Terminal 117 Cleanup

LONG-TERM MONITORING AND MAINTENANCE PLAN (LTMMP) PHASE 1: Sediment and Upland Cleanup

Lower Duwamish Waterway Superfund Site
Terminal 117 Early Action Area

Attachment A - EPA Comments on Draft LTMMMP

LONG-TERM MONITORING AND MAINTENANCE PLAN T-117 EARLY ACTION AREA		SEDIMENT AND GROUNDWATER MONITORING LOCATIONS - INTERIM COMPLETION
DATE: 4/18/2012	DRWN: BTS	FIGURE 2-1

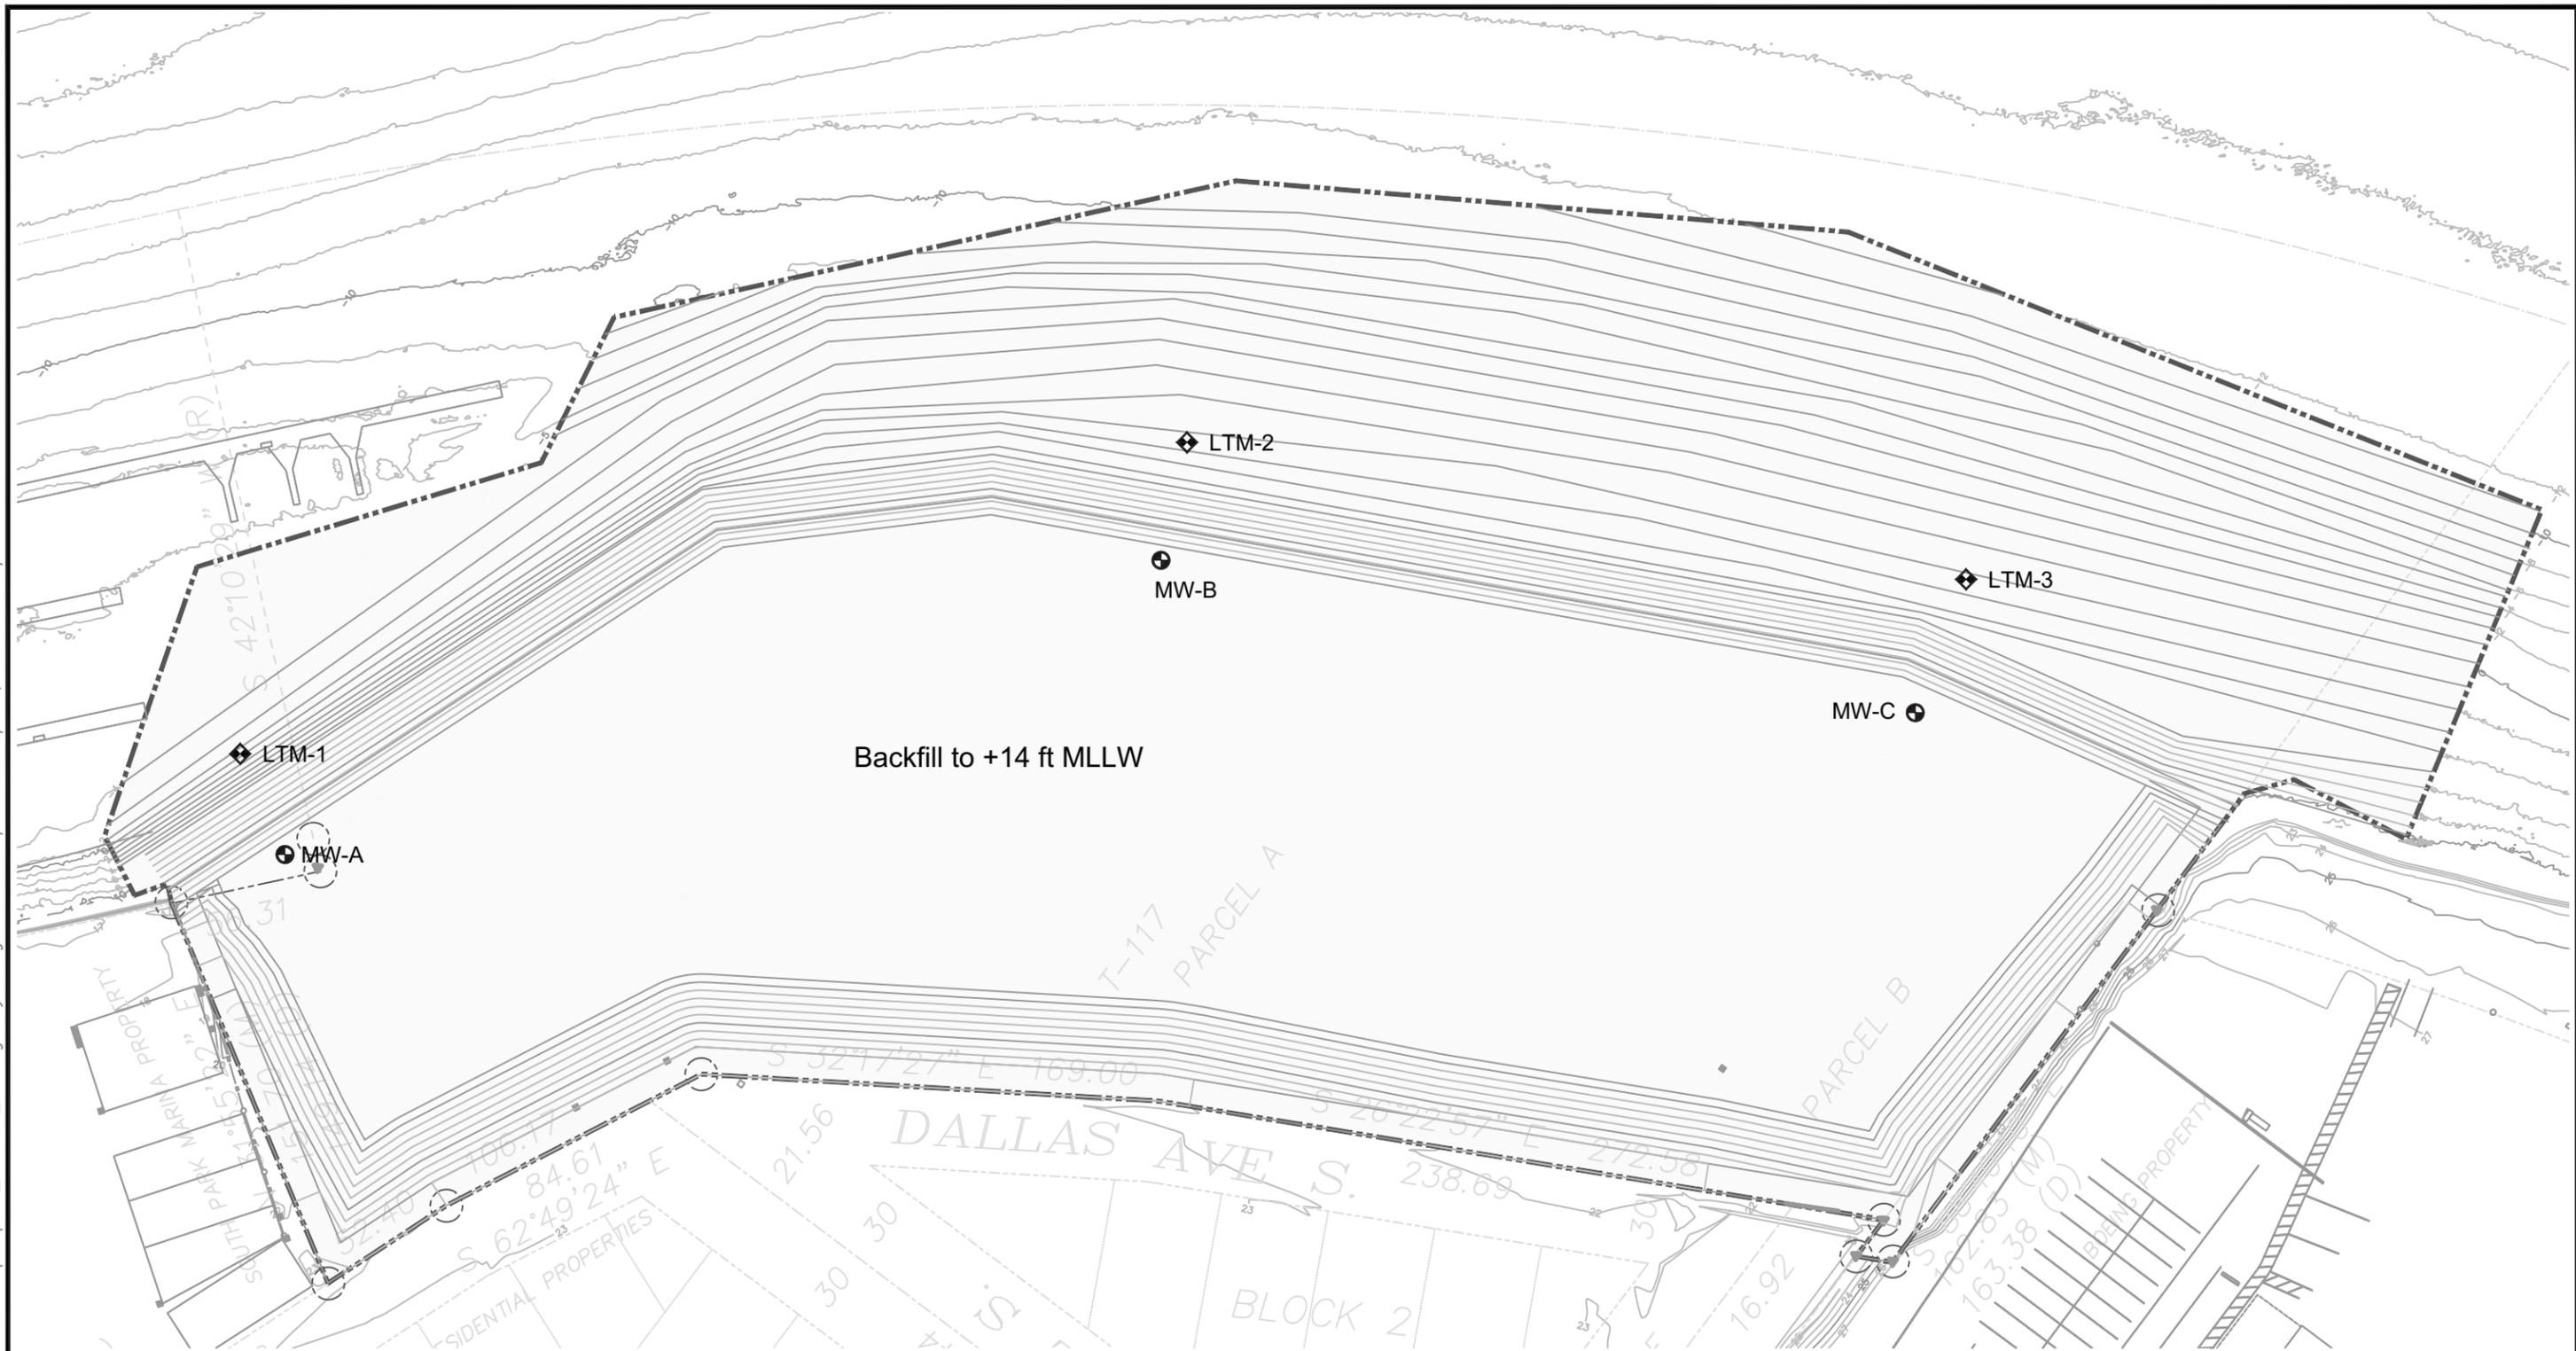
15	Fig 2-1 and 2-2 These figures only show 3 sediment sampling locations for long term monitoring. Figures in the draft final needs to be consistent with text and tables. EPA has not agreed to 3 sediment sampling locations.		x	No revision made in Draft LTMMMP, as this comment will be addressed in the Final LTMMMP.	should a placeholder be included in the text so that this issue is not missed during finalization of the LTMMMP. If EPA has not agreed to 3 sediment sampling locations should these be included at all? PORT: all outstanding LTMMMP comments have been included in Appendix A of the draft LTMMMP.

Figure 2-3 Shoreline Monitoring Well Detail

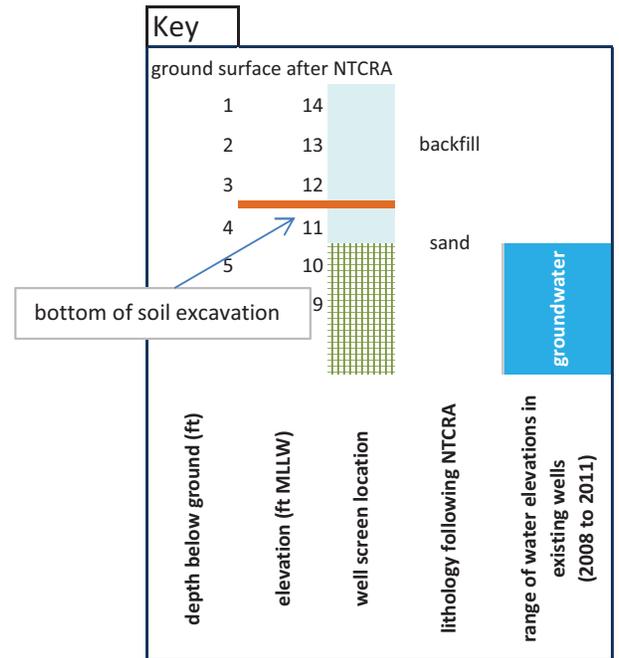
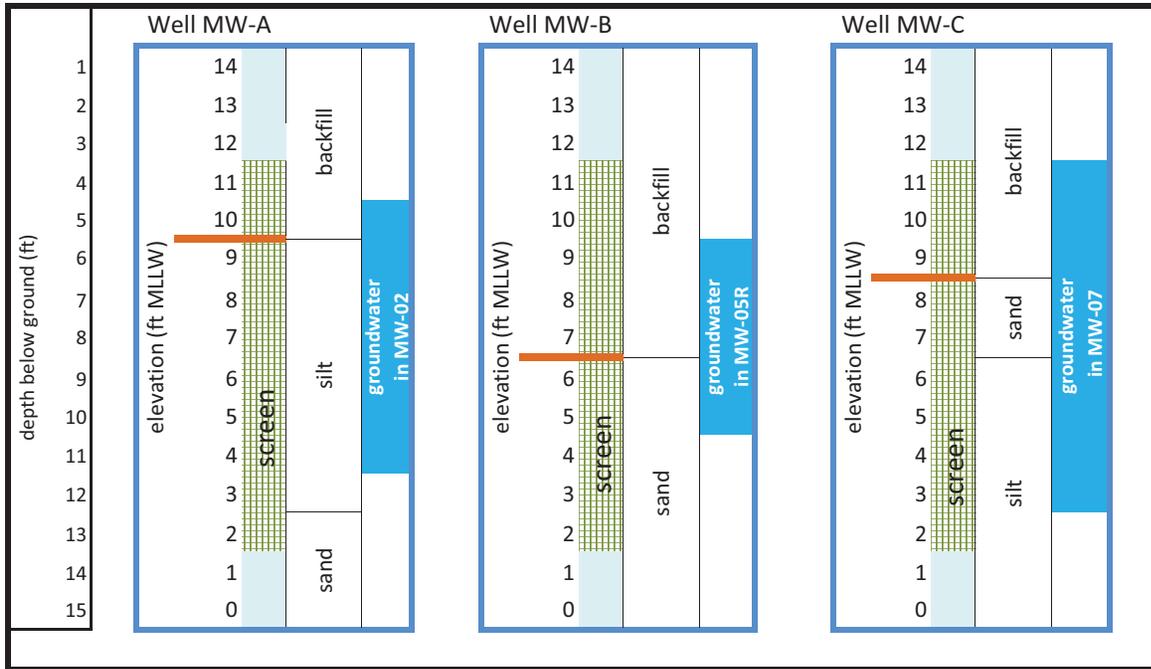
9	2.3.1.2, page 2-8 If the ground surface elevation is below 15 feet ("...between 14 and 15 ft MLLW...", and well screens are between 2 and 12 ft MLLW, the required minimum 3-ft vertical separation won't be met. If vertical separation is stated as a criterion, well screen depths should probably be adjusted as needed.	x		Text updated.	comment resolved
10	2.3.1.2, page 2-9, second paragraph, line 1 Change "...may be installed in an alternative site restoration is conducted" to "...may be installed if an alternative site restoration is conducted"	x		Text updated.	comment resolved
11	2.3.3 Statistical data evaluation methods are subject to EPA approval.	x		Text updated.	comment resolved
12	2.3.3 Duration of long term monitoring has not been established to be confined to 5 years. Revise this section and add footnote to Table 4-1, stating that sampling duration will be contingent on monitoring results	x		Section 2.3.3. revised to state the following: "Sampling frequency may be revised based on changes to site conditions and sample results, upon approval by EPA." Table 4-1 - A new note 1 was added to state the following: 1. Sampling frequency may be revised based on changes to site condition or sample results; any revisions must be approved by EPA.	comment resolved
